Proposed Residential Development – Bricket Wood Sports And Country Club, Paintball Site & Bricket Lodge, Lye Lane, Bricket Wood, AL2 3TF

Technical Note

Prepared on behalf of JK Rudkin Builders Limited

June 2023

Figure 2 Route 1 – Existing ‘Active’ Travel Network & Potential Improvements

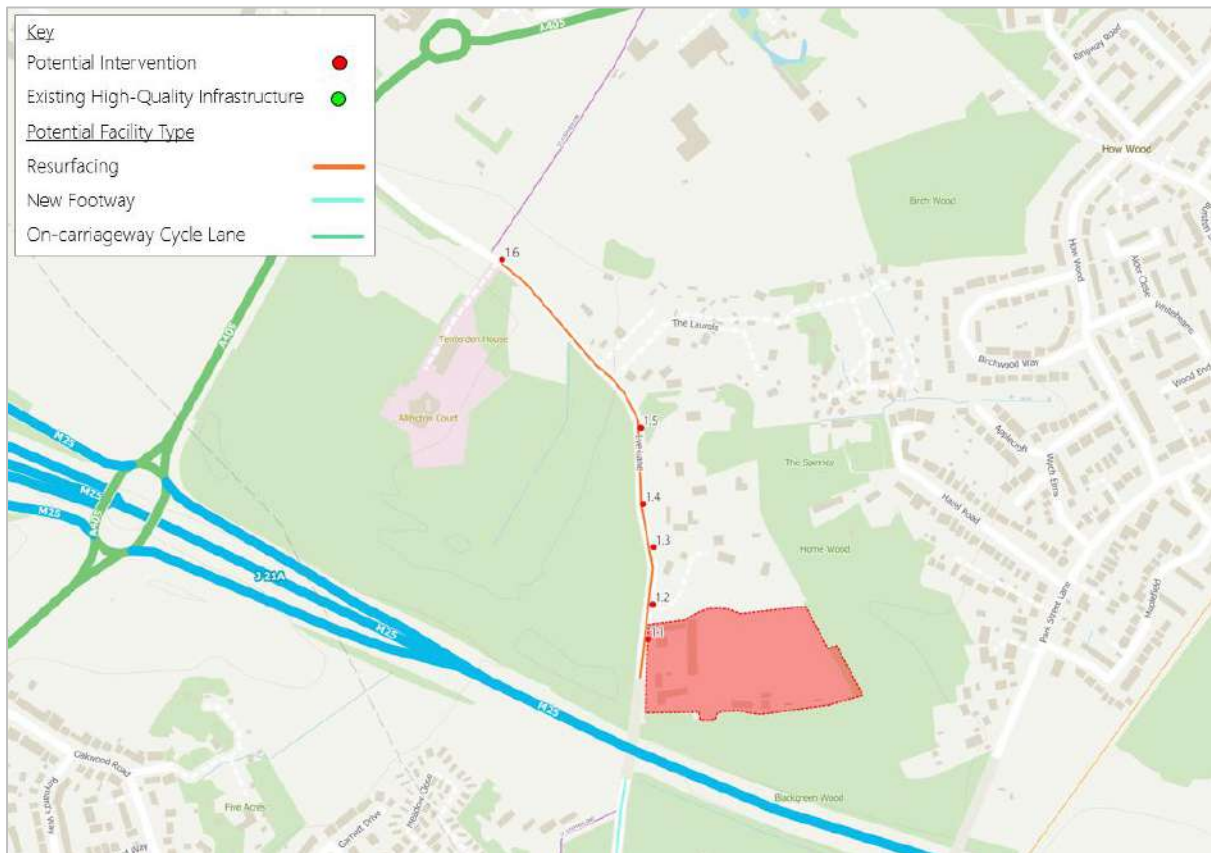
Table 3, along with Figure 2, reveals a key improvement for Route 1 would be further road cleaning / maintenance of potholes by the Highway Authority. This would result in a higher quality surface for 'active' travel users.

Highway Authority to consider carriageway resurfacing and verge maintenance, along with additional street lighting and signage, to provide ‘active’ travel users with a safer environment.

Figure 3 Route 2 – Existing 'Active' Travel Network & Potential Improvements

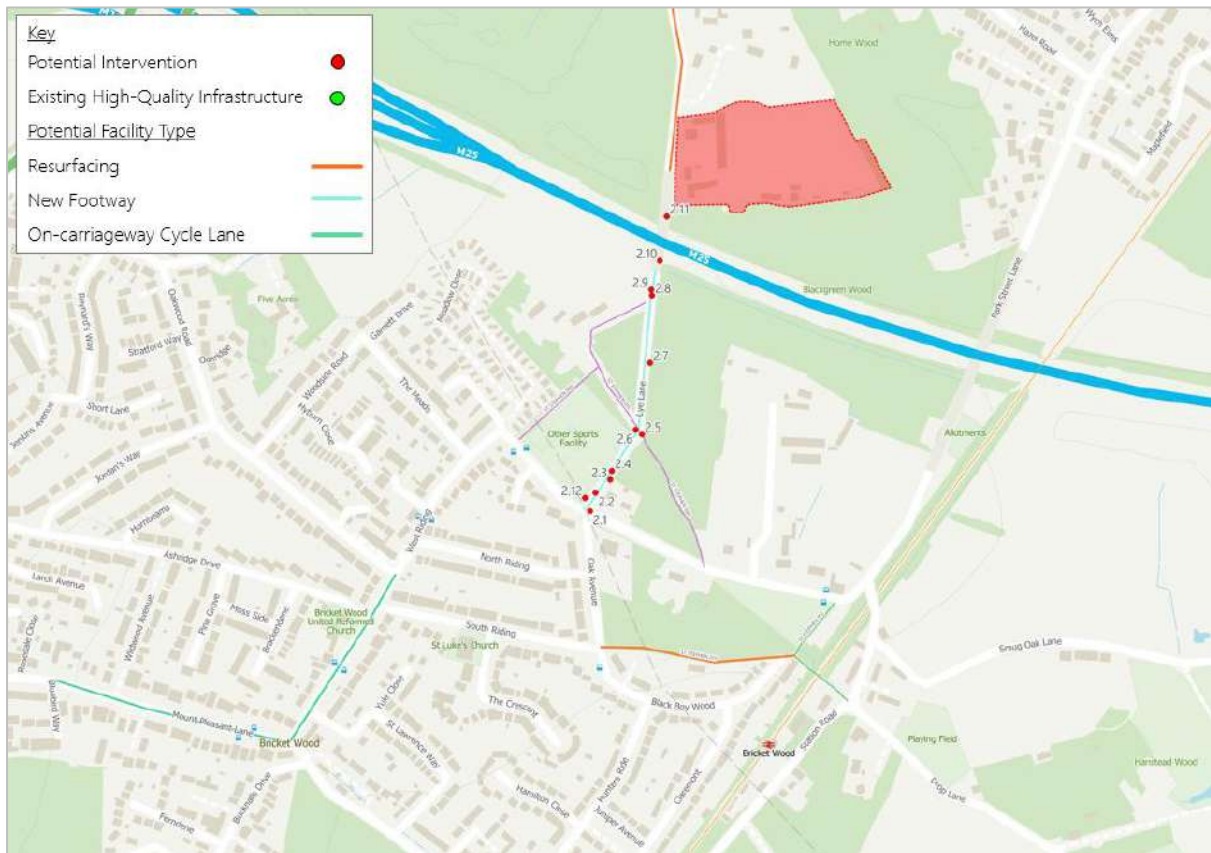
Table 2, along with Figure 3, reveals a key improvement for Route 2 would be the provision of a new footway connecting the Site to the existing footway provision on the M25 overbridge, as well as continuing south along Lye Lane to the give-way priority junction with West Riding.

Consider provision of new footway, dropped kerbs, and tactile paving.

Figure 4 Route 3 – Existing 'Active' Travel Network & Potential Improvements

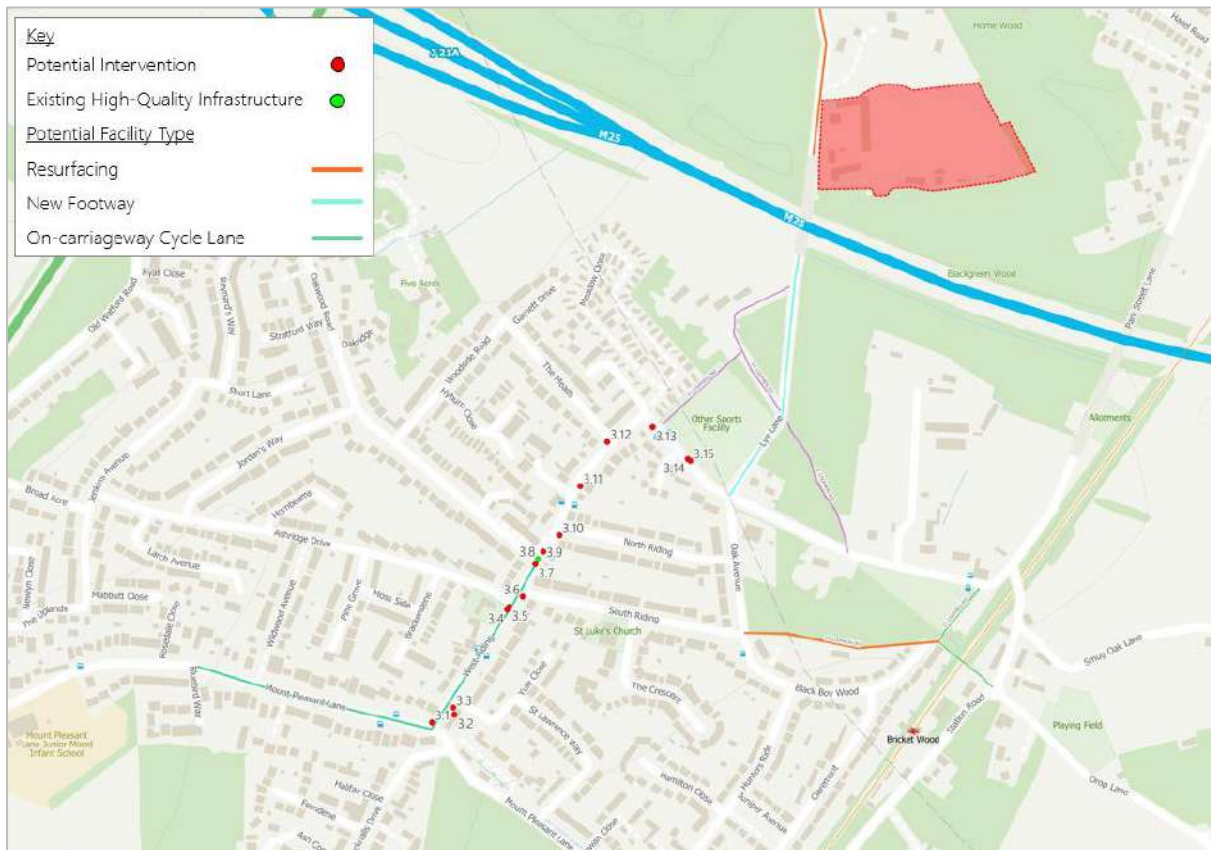
Table 3, along with Figure 4, reveals Route 3 could be improved through a combination of increased provision of dropped kerbs / tactile paving and increased cycle signage.

Consider provision of a new uncontrolled crossing comprising of dropped kerbs and tactile paving.

Figure 6 Route 5 – Existing 'Active' Travel Network & Potential Improvements

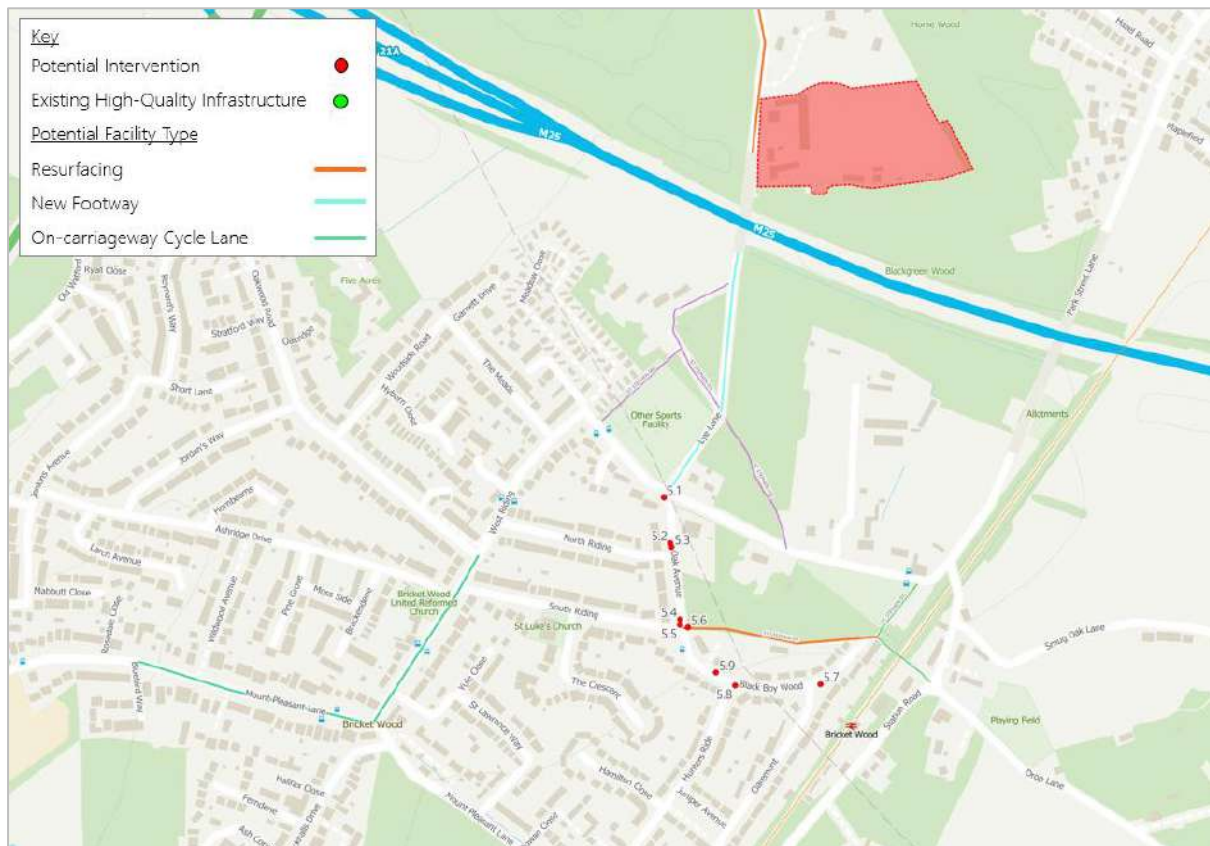
Table 5, along with Figure 6, reveals Route 5 could be improved through increased cycle signage and the provision of tactile paving and dropped kerbs where it is lacking.

Consider provision of new uncontrolled pedestrian crossing comprising of dropped kerbs and tactile paving.

Figure 7 Route 6 – Existing 'Active' Travel Network & Potential Improvements

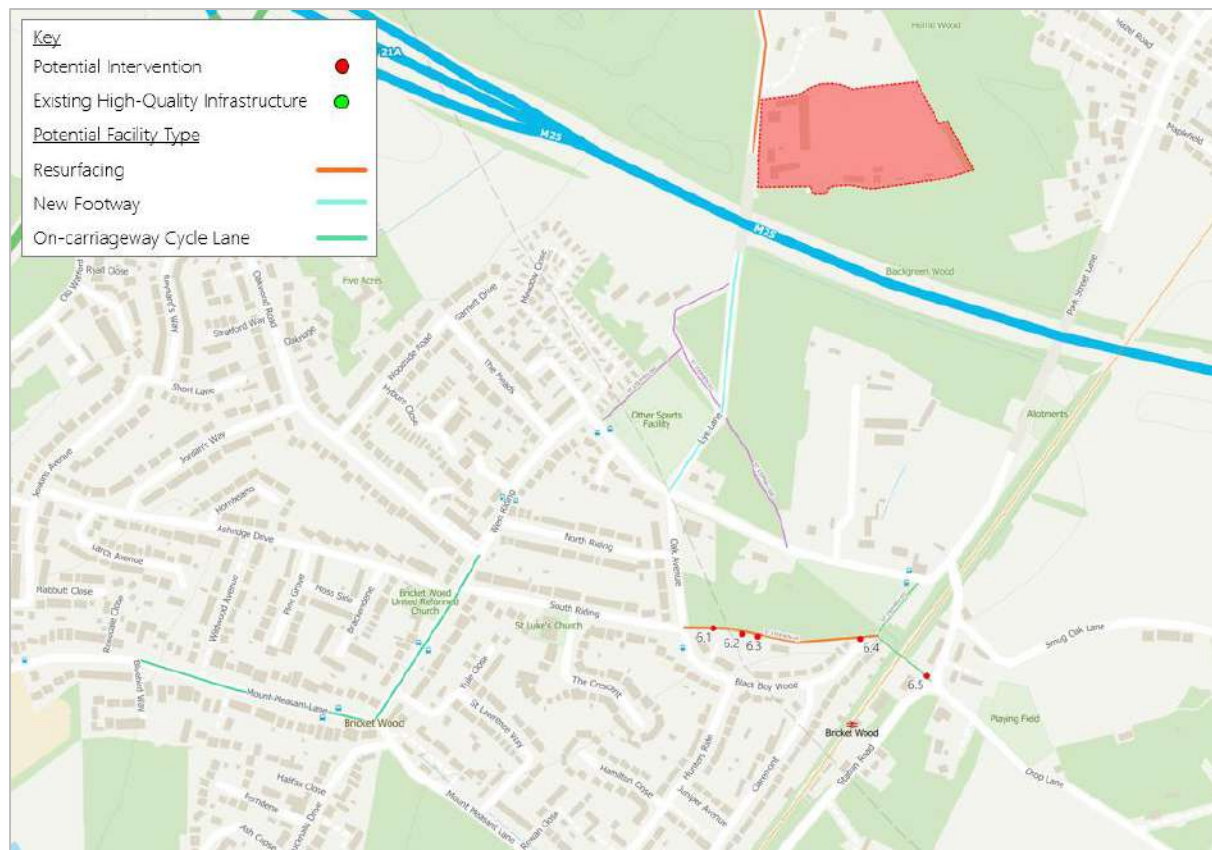
Table 6 reveals that Route 6 is considered direct and well segregated to motorised vehicles. However, Table 6, along with Figure 7, reveals Route 6 could be improved through increased cycle signage, lighting, and increased surface / verge maintenance by the Highway Authority.

Highway authority should consider increased verge maintenance, signage, and lighting.

Figure 8 Route 7 – Existing 'Active' Travel Network & Potential Improvements

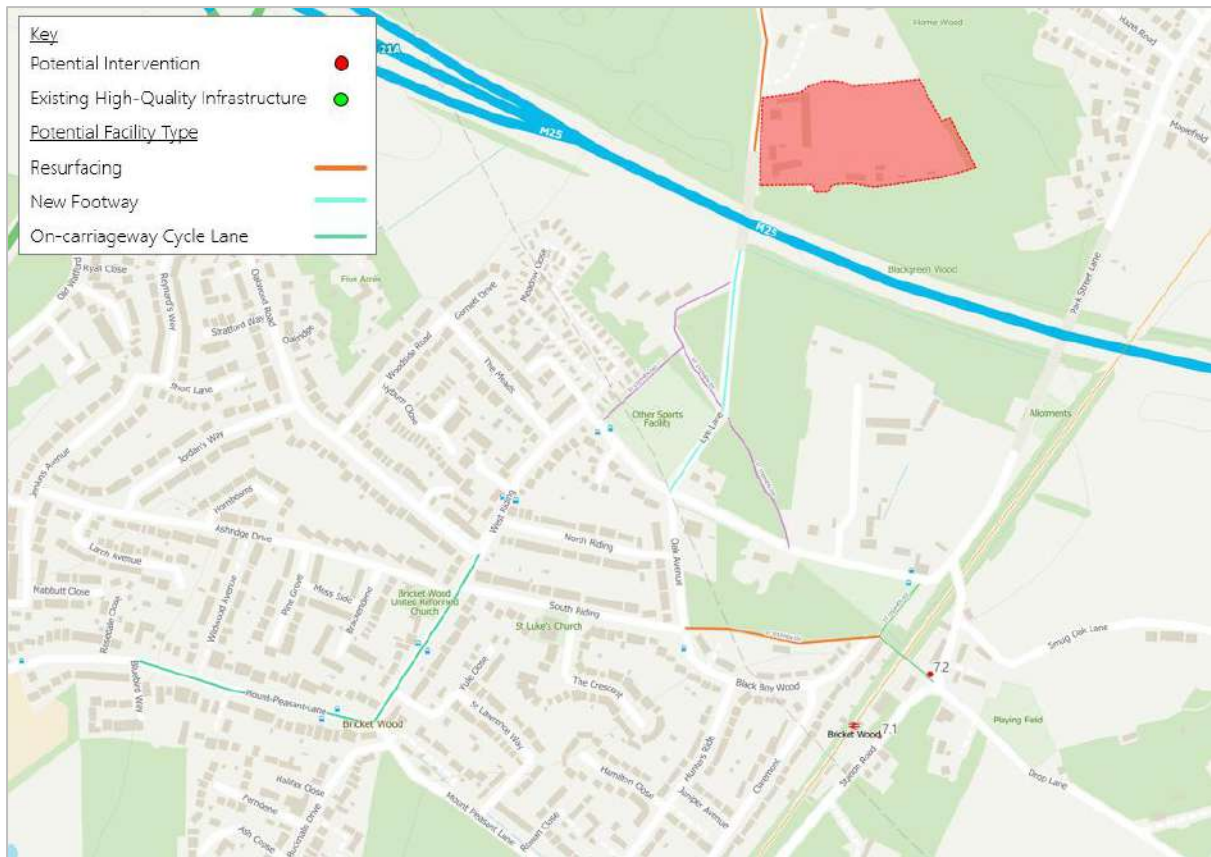
Table 7, along with Figure 8, reveals Route 6 could be improved through increased cycle signage. It was also observed that the access to Bricket Wood rail station would benefit from the provision of tactile paving and dropped kerbs.

Consider provision of new uncontrolled pedestrian crossing comprising of dropped kerbs and tactile paving.

Title: Proposed 'Active' Travel Improvements to Lye Lane (Sheet 2 of 7)

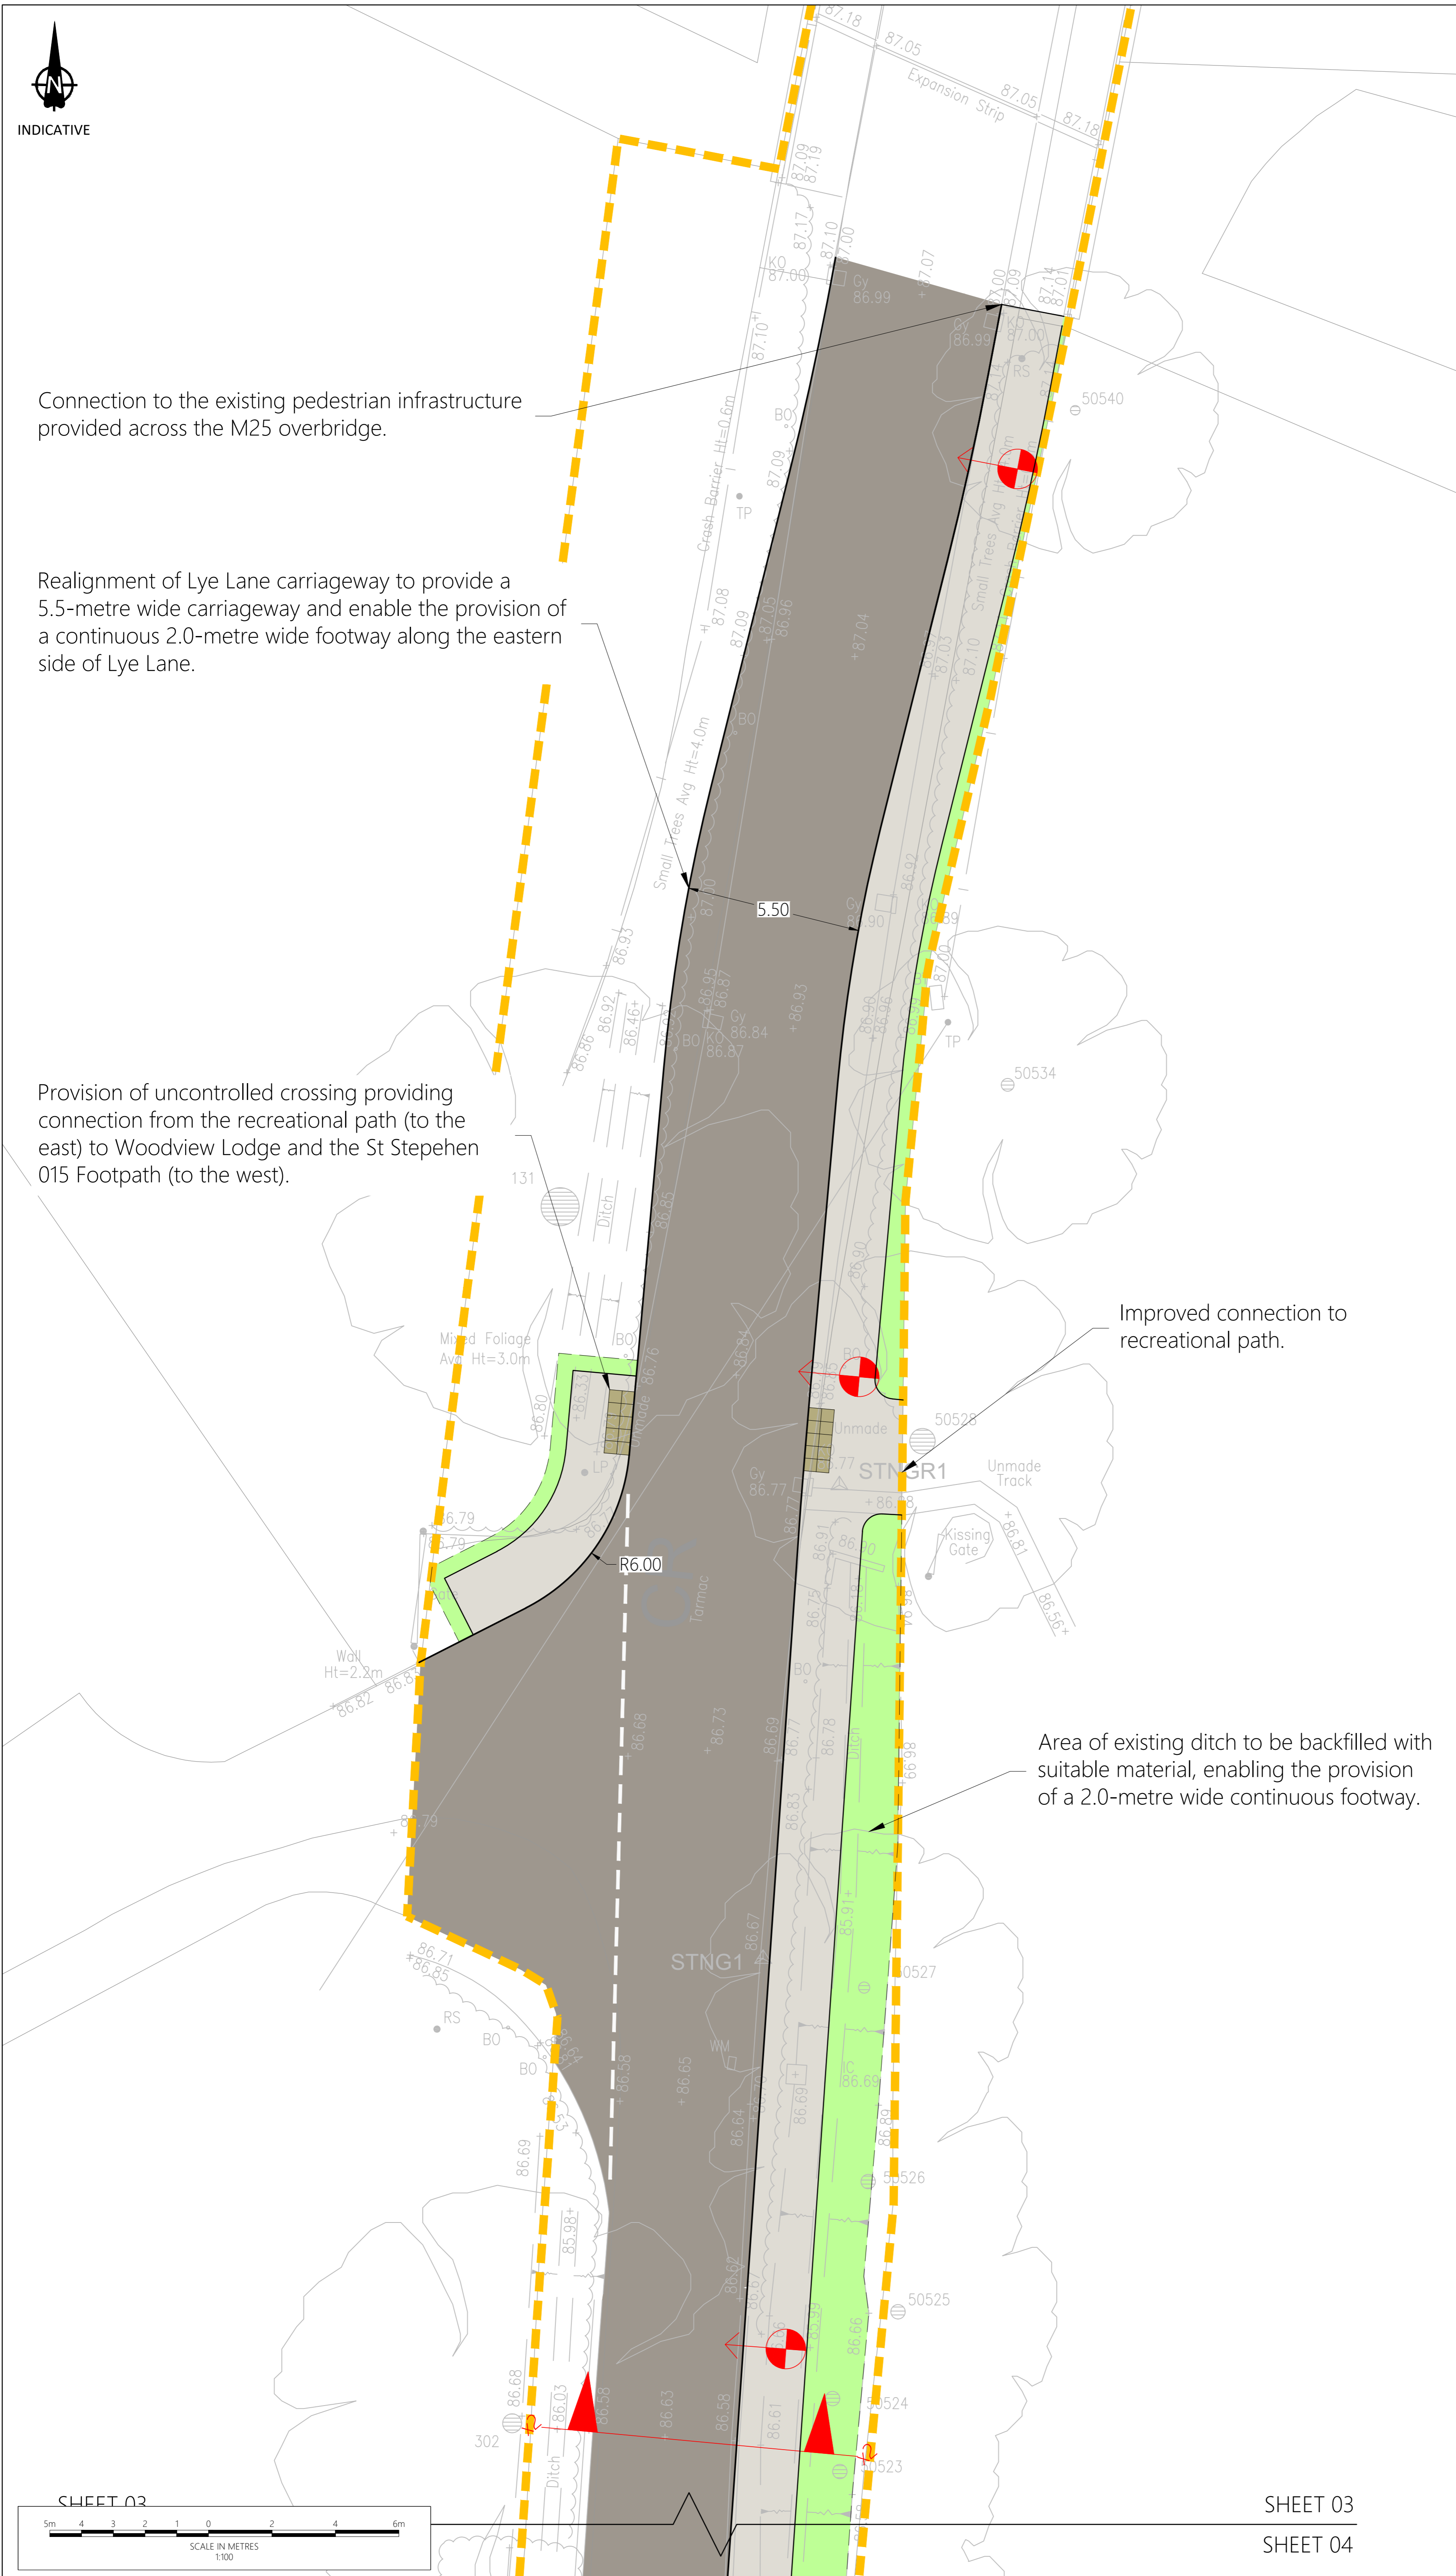
As shown on Drawing No. 23051 / 001, in order to provide pedestrians with a direct route south along Lye Lane, it is proposed that Lye Lane carriageway will be realigned south-westward to provide a 5.5-metre wide carriageway, enabling the provision of a continuous 2.0-metre wide footway along the eastern side of Lye Lane. The realigned western kerb line will tie back into the existing carriageway adjacent to Woodview Lodge, whilst the eastern kerb line will tie back into the existing carriageway circa 40-metres further south.

An uncontrolled crossing, provided with dropped kerbs and tactile paving, is proposed adjacent to Woodview Lodge. This will provide an improved connection between the recreational path, to the east, and to Woodview Lodge / the St Stephen 015 Footpath, to the west. This was an area identified for improvement within the ATA.

Realignment of Lye Lane carriageway to provide a 5.5-metre wide carriageway and enable the provision of a continuous 2.0-metre wide footway along the eastern side of Lye Lane.

Provision of uncontrolled crossing providing connection from the recreational path (to the east) to Woodview Lodge and the St Stephen 015 Footpath (to the west).
